The attached file, "RAI 354 Supplement 21 Response US EPR DC - PUBLIC.pdf" provides a technically correct and complete response to question 03.08.02-11, as committed. Because the response file contains security-related sensitive information that should be withheld from public disclosure in accordance with 10 CFR 2.390, a public version is provided with the security-related sensitive information redacted. This email and attached file do not contain any security-related information. An unredacted security-related version is provided under separate email.

Appended to this file are affected pages of the U.S. EPR Final Safety Analysis Report in redline-strikeout format which support the response to RAI 354 Question 03.08.02-11.

Subject: Response to U.S. EPR Design Certification Application RAI No. 354, FSAR Ch. 3, Supplement 20 (Part 3 of 3)

Figure 03.08.02-11-1—ANSYS Model (Personnel and Emergency Airlocks)

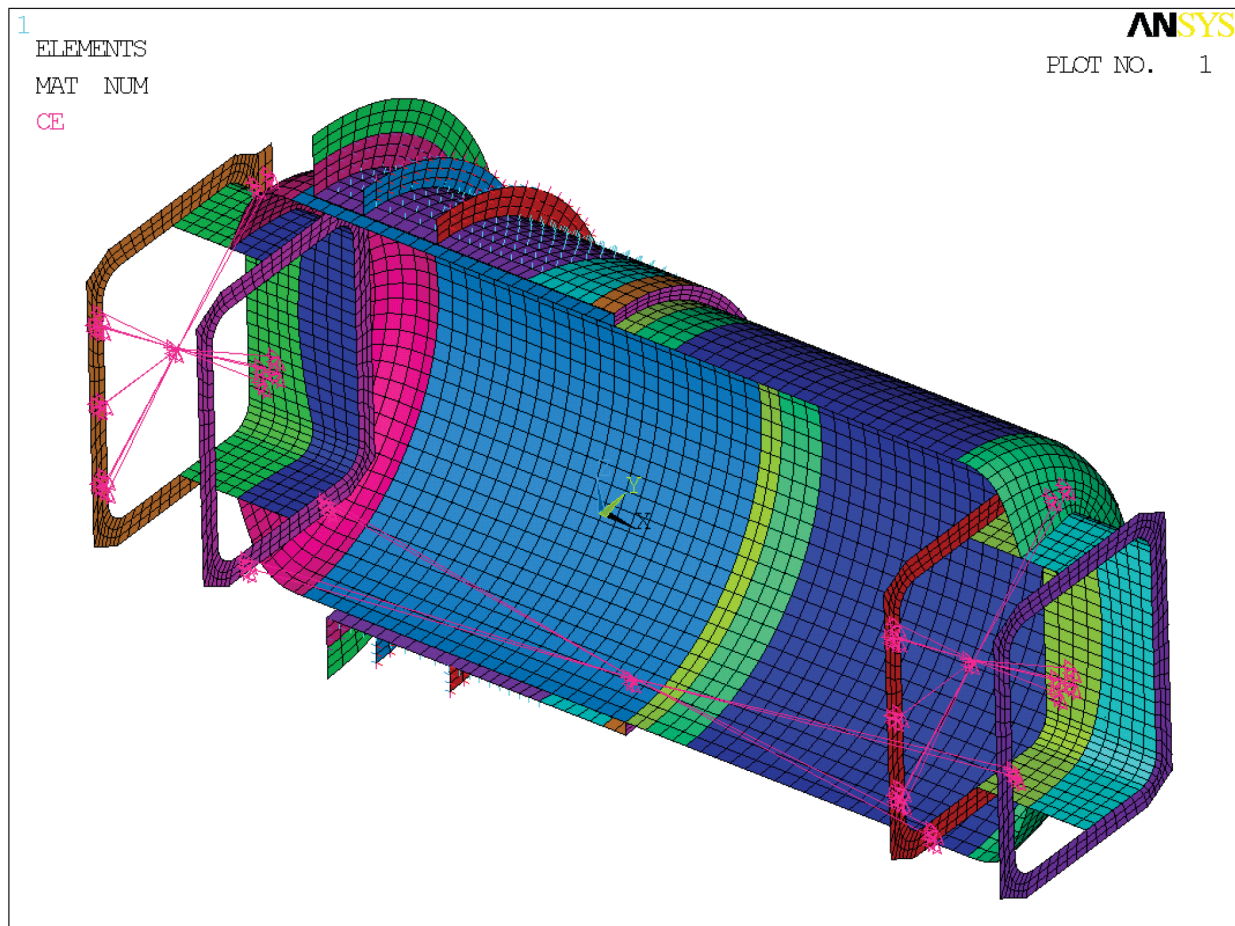
Analysis methods use finite element modeling techniques to represent the penetration assemblies and interfaces at the containment boundary. Figure 03.08.02-11-1 is used to evaluate the personnel and emergency airlocks. Loads and load combinations for design, testing, and Service Levels A, B, C, and D are evaluated. Load cases consider conditions of operations, such as inner hatch closed or open, loadings associated with ancillary equipment of the penetration such as hatch doors, and built-up floors.

Figure 3.8-119—Containment Dedicated Spare Piping Penetrations ~~(Typical)~~

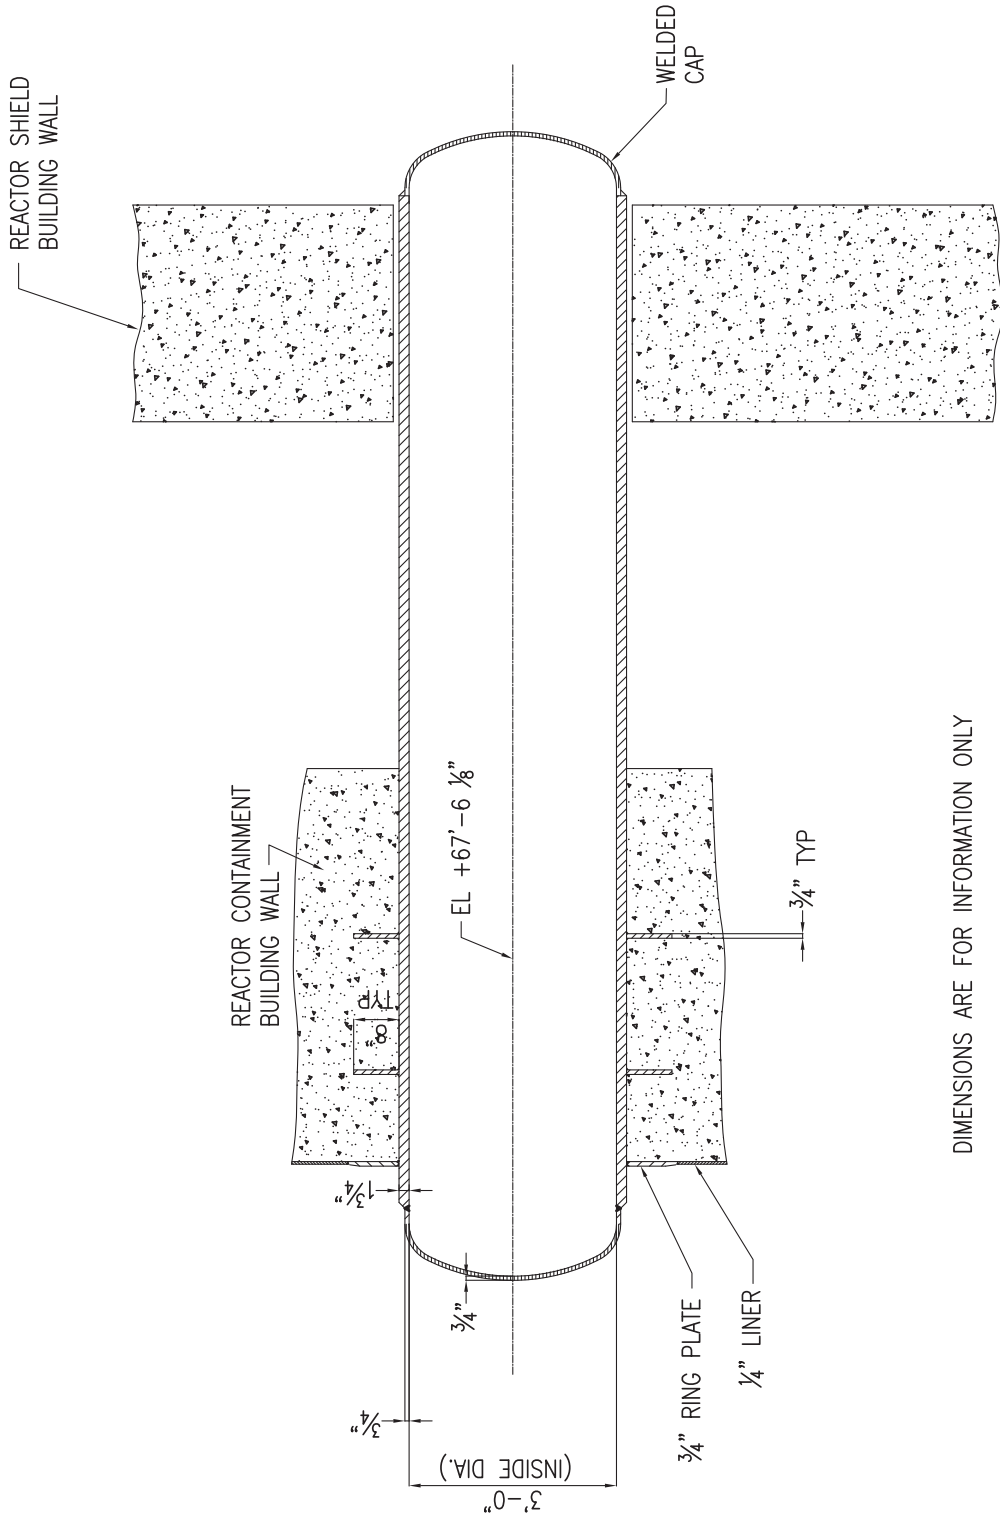
The containment penetrations for the personnel and emergency airlocks, closure for the construction opening, equipment hatch, main steam and feedwater piping, and fuel transfer tube have been evaluated to verify the integrity of the containment pressure boundary. The U.S. EPR design also includes a 36-inch diameter spare containment penetration that is dedicated for post-accident conditions as described in U.S. EPR FSAR Tier 2, Section 19.2.3.3.8. Additional discussion of the dedicated spare penetration will be added to U.S. EPR FSAR Tier 2, Section 3.8.2.4.1, and Figure 3.8-119 is revised to show the detail of the dedicated spare penetration.

The containment penetrations also include a 36-inch diameter spare containment penetration as shown in Figure 3.8-119. This penetration is dedicated for post-accident conditions as described in Section 19.2.3.3.8.

The 36-inch diameter dedicated containment spare penetration for containment filtered pressure release is shown in Figure 3.8-119. The portions of the penetration that fall under the jurisdiction of ASME BPV, Subsection NE are bounded by the construction opening closure. The spare penetration has the same cap thickness, but smaller opening size compared to the construction opening closure. Therefore, the stresses in the NE portions of the spare penetration are bounded by the stresses calculated for the construction closure opening. The portions of the penetration that fall under the jurisdiction of ASME BPV, Subsection CC are bounded by the main steam line penetration. The spare penetration is located at a similar elevation, has the same thickness, but smaller opening size compared to the main steam line penetration. Therefore, the strains induced in the CC portions of the spare penetration are bounded by the strains calculated for the main steam line.
